Subject: Submittal Supporting Accelerated ABWR Review Schedule - Revised LCO
3.7.5

Enclosed is a SSAR markup of the revised LCO 3.7.5, Main Turbine Bypass System.

Enclosed are revised LCOs 3.5.1 and 3.7.1 and associated bases. These are intended to replace LCOs 3.5.1 and 3.7.1 issued for P&R dated 7/22/93 and 7/30/93, respectively, in their entirety.

Figure 1. Turbine Bypass Valve Hydraulic Fluid Control Loop

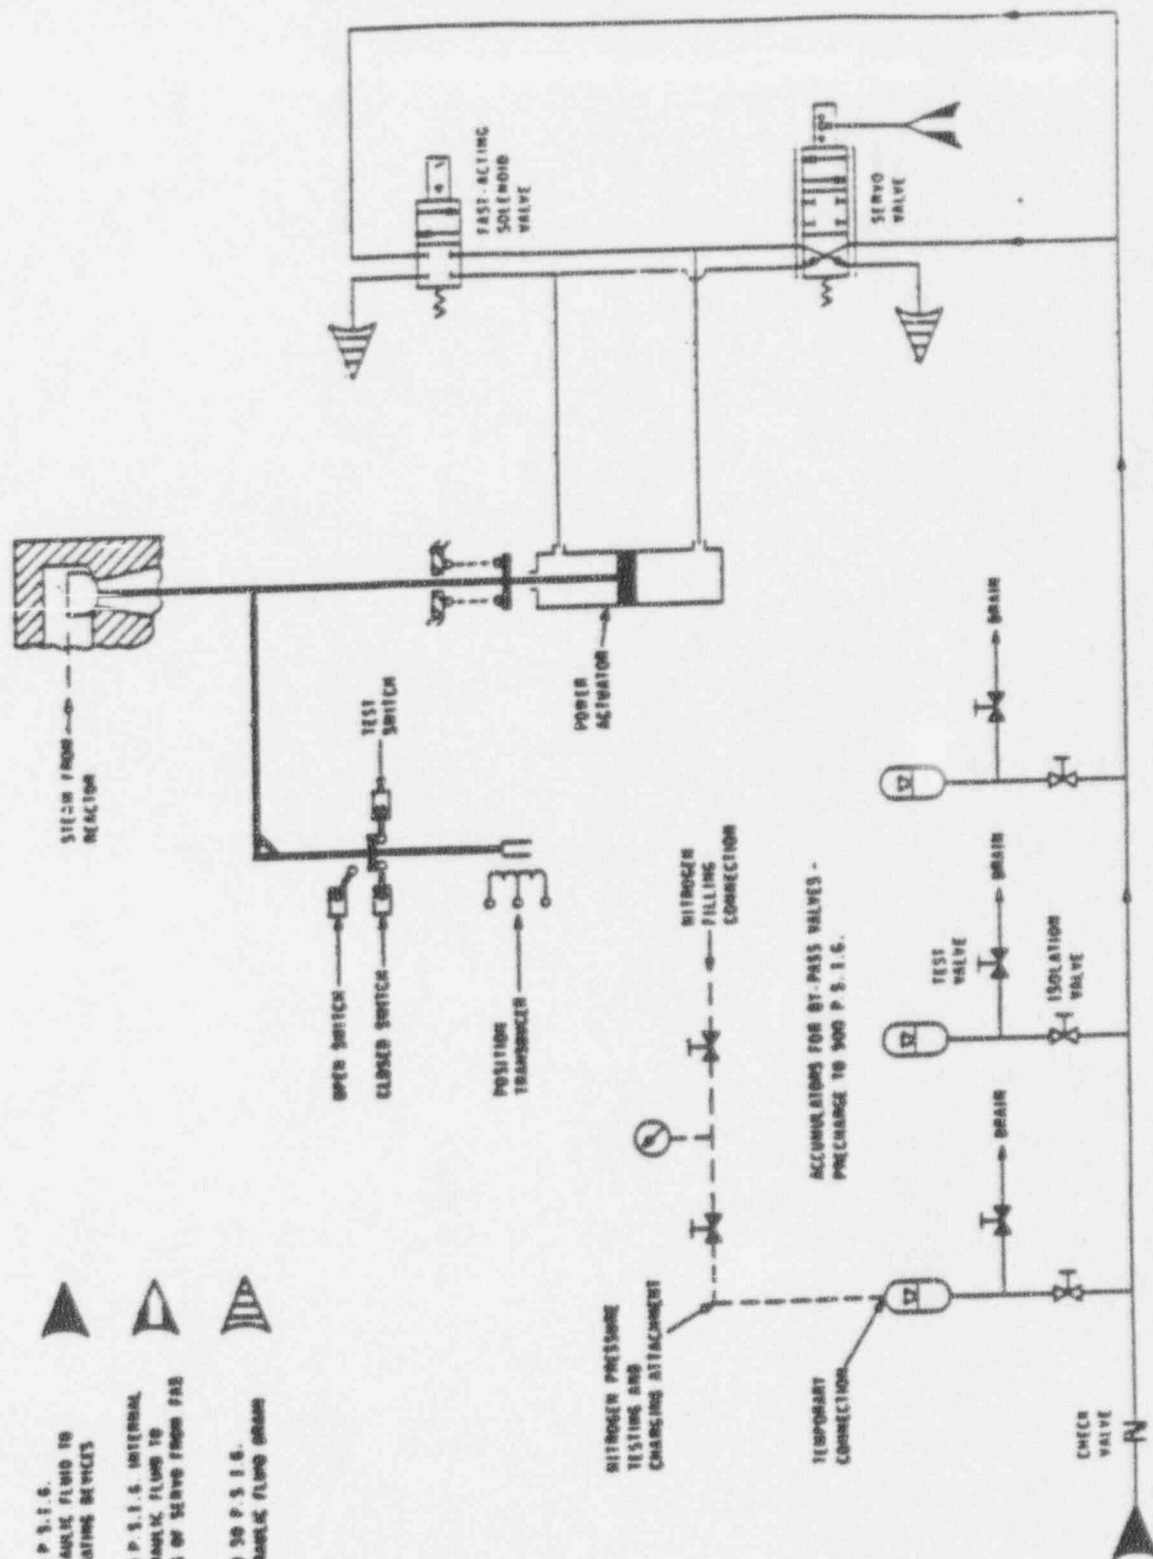
If a turbine trip occurs at high power, even fast action of the bypass valves will not avoid reactor scram. However, the proper BPV function will limit the pressure rise in the reactor. The hydraulic fluid loop showing the fast acting solenoid valve (FASV) and its connection to the BPV is shown in Figure 1. The FASV is the key to fast opening of BPVs.

Bypass valves of current BWRs in the U.S. are tested monthly in a test that includes slow stroking for 90% of valve travel followed by rapid stroke for the final 10% of travel. This monthly test frequency has no technical basis and was established on the basis of other turbine valve testing. Because of the 11% power capability of a single bypass valve in the ABWR plant, it is desirable to test the full stroke and fast travel of bypass valves only during plant shutdown, approximately every two years, to minimize disturbance to the electrical grid and to minimize potential challenges to the plant safety systems. At shutdown the total valve stroke time can be measured. The valves can be stroked slowly during plant operation over partial travel (such as 10%) to assure that they are not bound and will open on demand. Such a test will have little impact on operation.

FIGURE 2. TURBINE BYPASS VALVE FAST ACTING SOLENOID VALVE CONTROL CIRCUIT

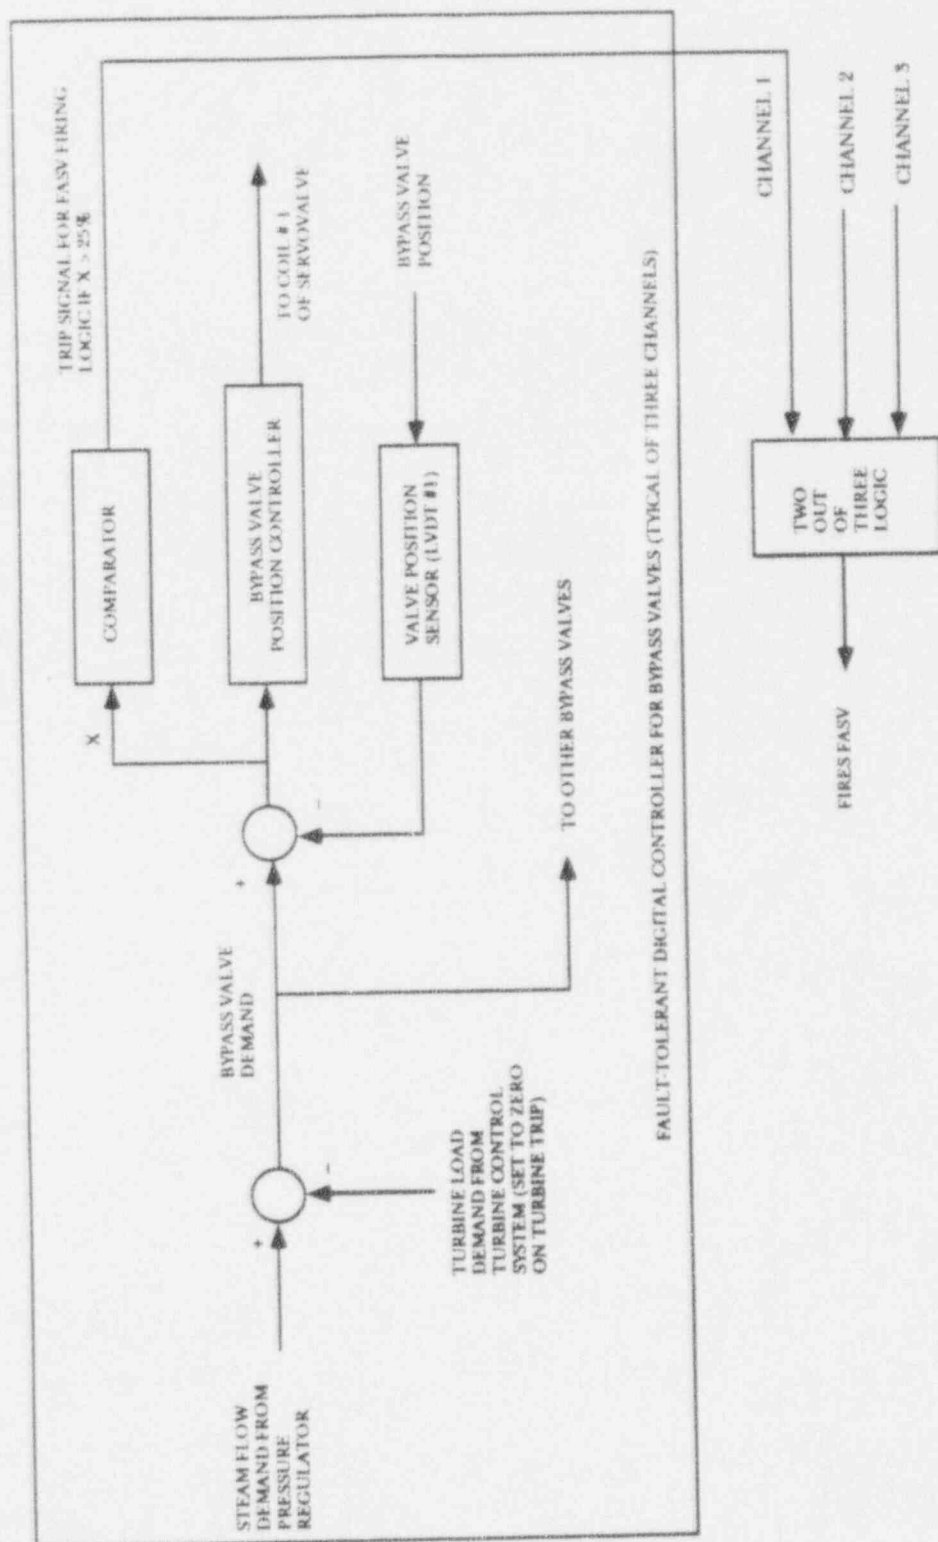
The circuit to cause fast opening of the BPV is attached as Figure 2. The fault tolerant, solid state digital controller components are checked frequently by the self-check circuits. They are also combined in 2-out-of-3 logic so there will be a very low probability of failures of the controller that lead to inadvertent opening of the fast acting solenoid valves (FASVs). Because of the high reliability of this circuit, the main contributor to failure of the FASV to perform its desired function will be the FASV itself.

The referenced IEEE Standard gives failure rates for much nuclear plant equipment, including solenoid valves. The "all modes" failure rate for solenoid valves is $1.32\text{E-}6/\text{h}$, but this is primarily for "catastrophic" (spurious open or spurious close) failures, $0.95\text{E-}6/\text{h}$. The failure rate for "degraded" performance is $0.37\text{E-}6/\text{h}$. A demand failure rate of $1.08\text{E-}6/\text{d}$ is also given in IEEE 500-1984.

FIGURE 2. TURBINE BYPASS VALVE FAST ACTING SOLENOID VALVE CONTROL CIRCUIT

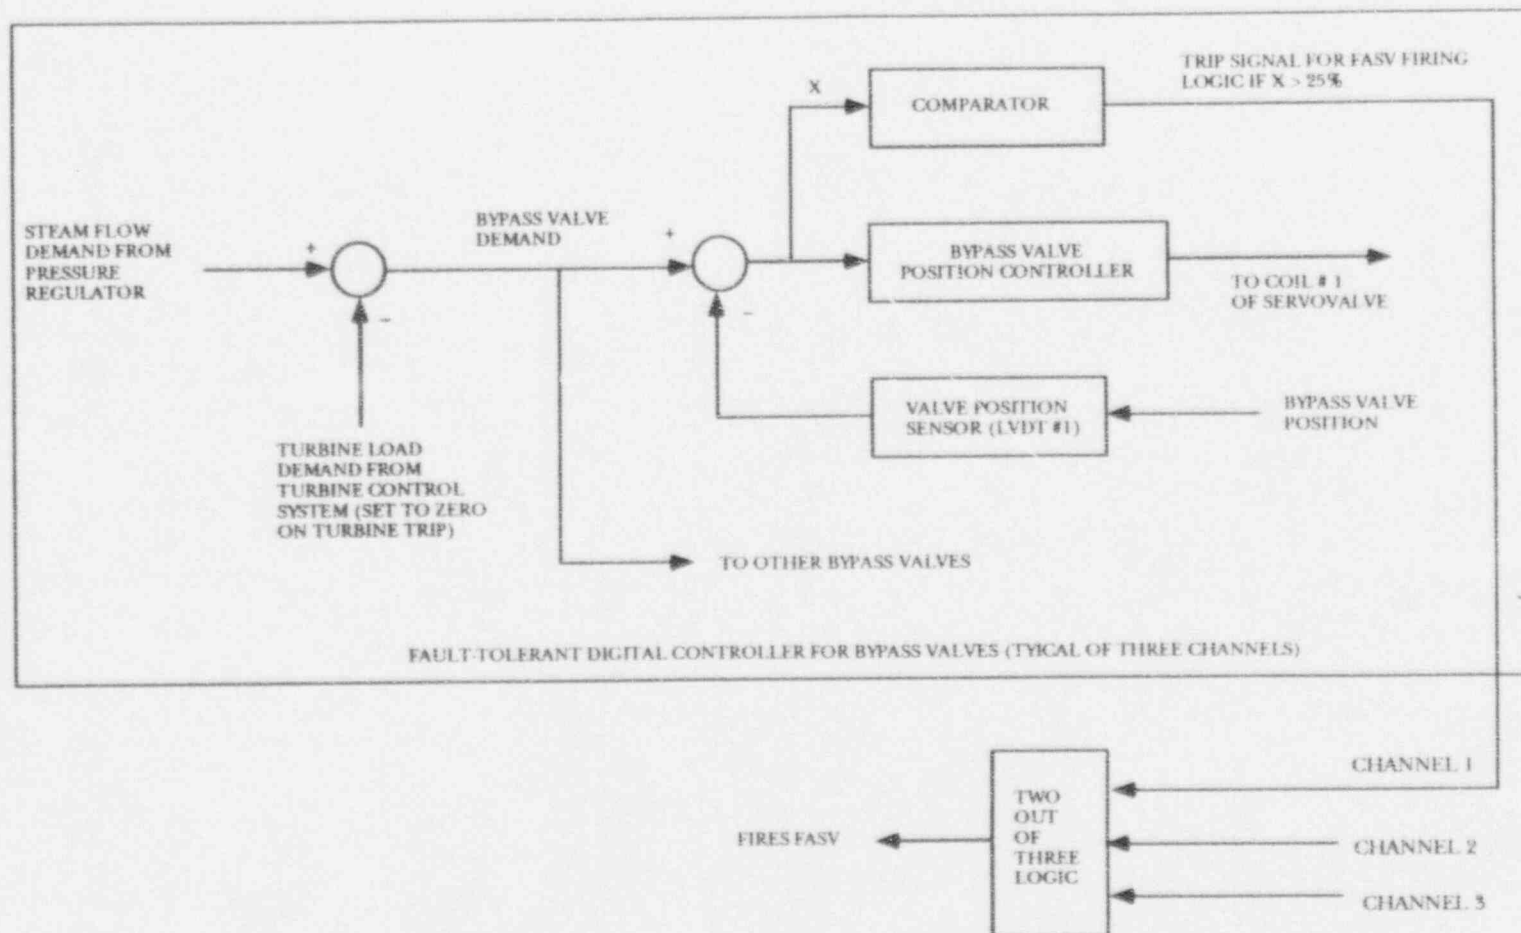
The circuit to cause fast opening of the BPV is attached as Figure 2. The fault tolerant, solid state digital controller components are checked frequently by the self-check circuits. They are also combined in 2-out-of-3 logic so there will be a very low probability of failures of the controller that lead to inadvertent opening of the fast acting solenoid valves (FASVs). Because of the high reliability of this circuit, the main contributor to failure of the FASV to perform its desired function will be the FASV itself.

The referenced IEEE Standard gives failure rates for much nuclear plant equipment, including solenoid valves. The "all modes" failure rate for solenoid valves is $1.32\text{E-}6/\text{h}$, but this is primarily for "catastrophic" (spurious open or spurious close) failures, $0.95\text{E-}6/\text{h}$. The failure rate for "degraded" performance is $0.37\text{E-}6/\text{h}$. A demand failure rate of $1.08\text{E-}6/\text{d}$ is also given in IEEE 500-1984.
